REVISION TRANSMITTAL

This sheet transmits Revision 1 to MTL-36-01, which:

PNEUMATIC - ENGINE FLOW PACK T-FITTING INSPECTION

MTL-36-01
Page 1 of 6

Figure 1. Engine Bleed Air System Tube Assembly Replacement (Sheet 1)

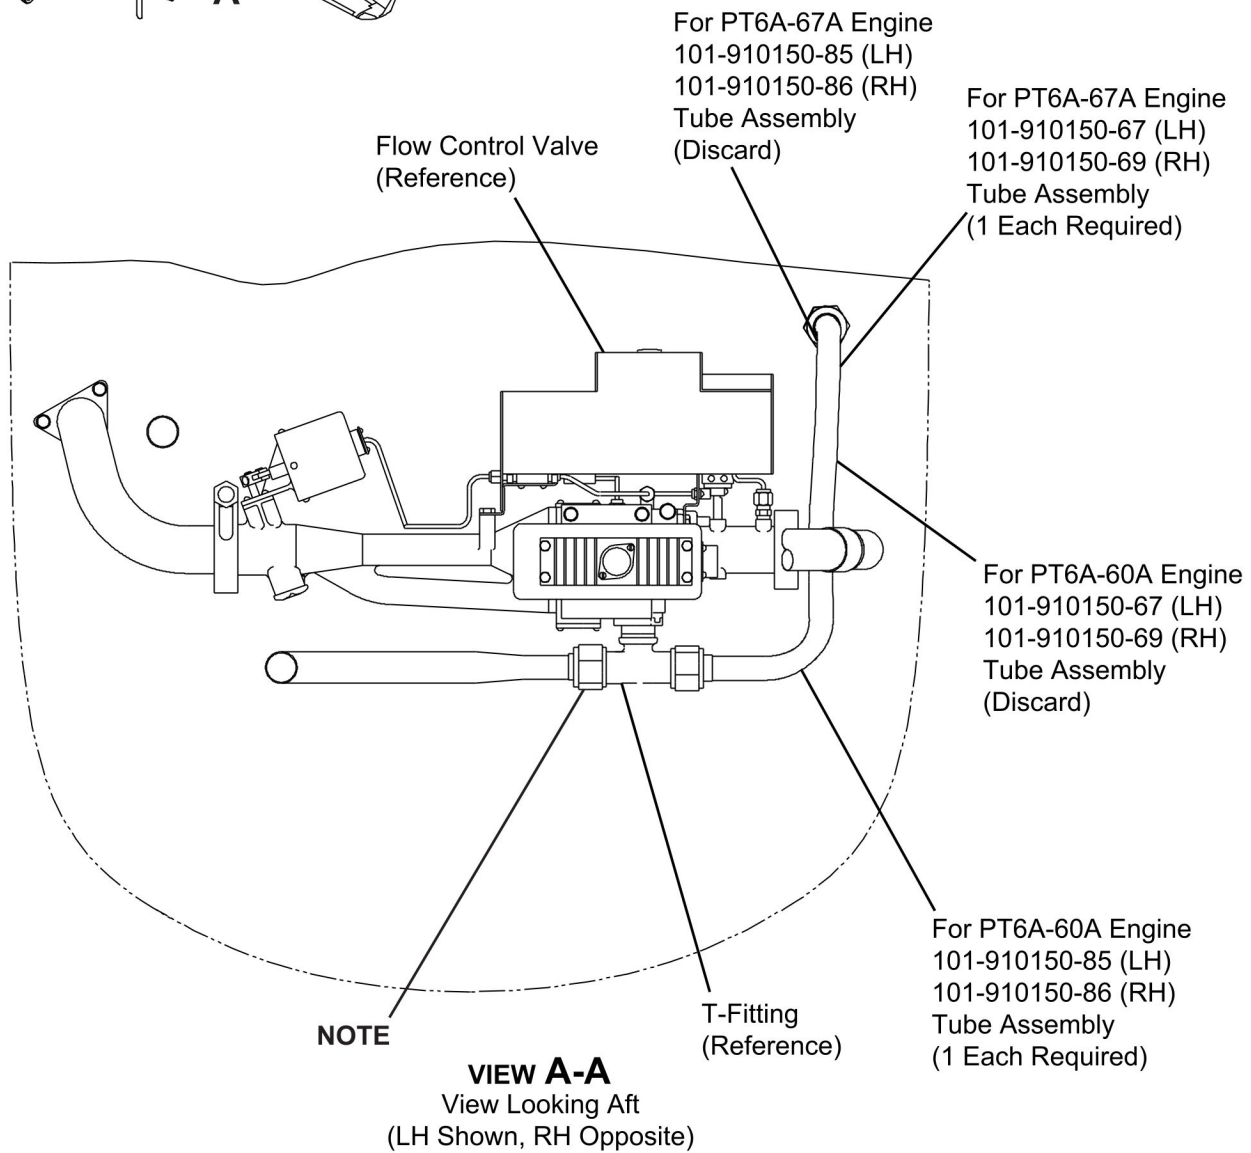
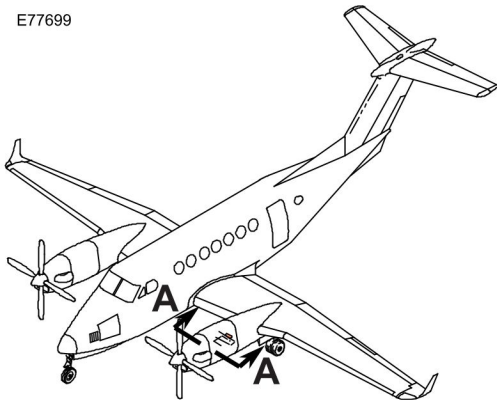
- A. Corrected engine reference from PT6A-67 to PT6A-67A.
- B. Corrected Figure 1, Sheets 1 and 2.
- C. Added a Note under Steps 4. B. and 5. B.

4. (Refer to Figure 1, Sheet 1 and 2.) For airplanes fitted with PT6A-67A engine, do an inspection of the LH engine bleed air system tube assembly.
 - A. If 101-910150-67 Tube Assembly is installed, go to Step 6.

- (2) Disconnect both ends of the 101-910150-85 Tube Assembly from the bulkhead union and T-fitting.
 - (a) Remove and discard the 101-910150-85 Tube Assembly.

- (4) Insulate the 101-910150-67 Tube Assembly with BS272-HH Fiberglass Insulation and wrap with 002X3W Aluminum Foil Tape.
 - (5) Connect new 101-910150-67 Tube Assembly to the bulkhead union and T-fitting.

Figure 1. Engine Bleed Air System Tube Assembly Replacement (Sheet 2)

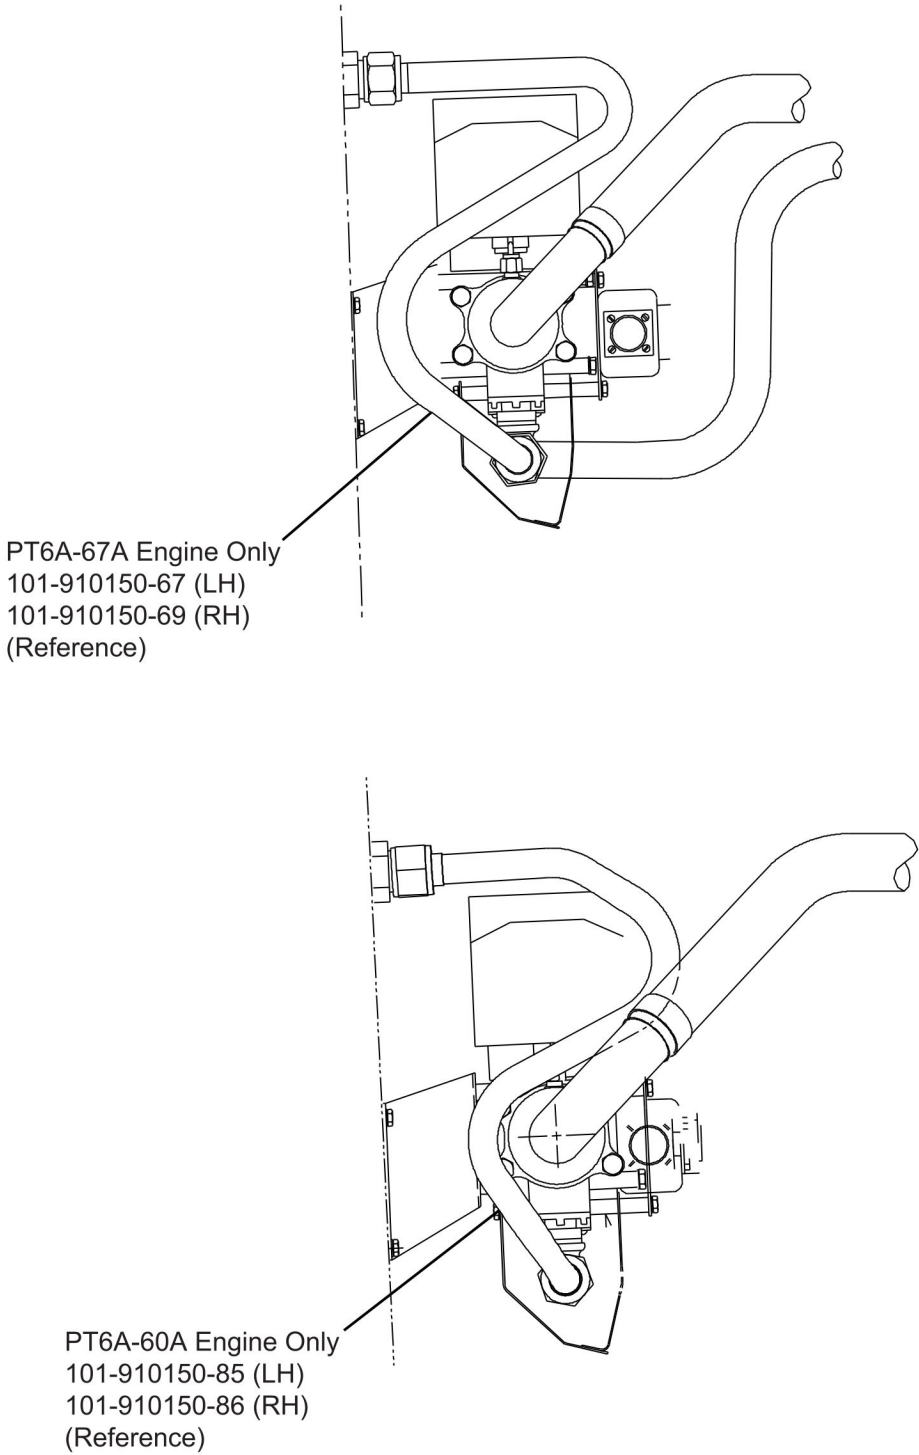
- (6) Go to Step 6.
5. (Refer to Figure 1, Sheet 1 and 2.) For airplanes fitted with PT6A-60A engine, do an inspection of the LH engine bleed air system tube assembly.

- (1) Remove and keep the heat shield that surrounds the T-Fitting.
 - (2) Disconnect both ends of the 101-910150-67 Tube assembly from the bulkhead union and T-fitting.

- (4) Connect new 101-910150-85 Tube Assembly to the bulkhead union and T-fitting.
 - (a) Torque the nut at both ends. (Refer to the Beechcraft King Air Standard Practices Manual, Chapter 20, Torque Application - Maintenance Practices.)
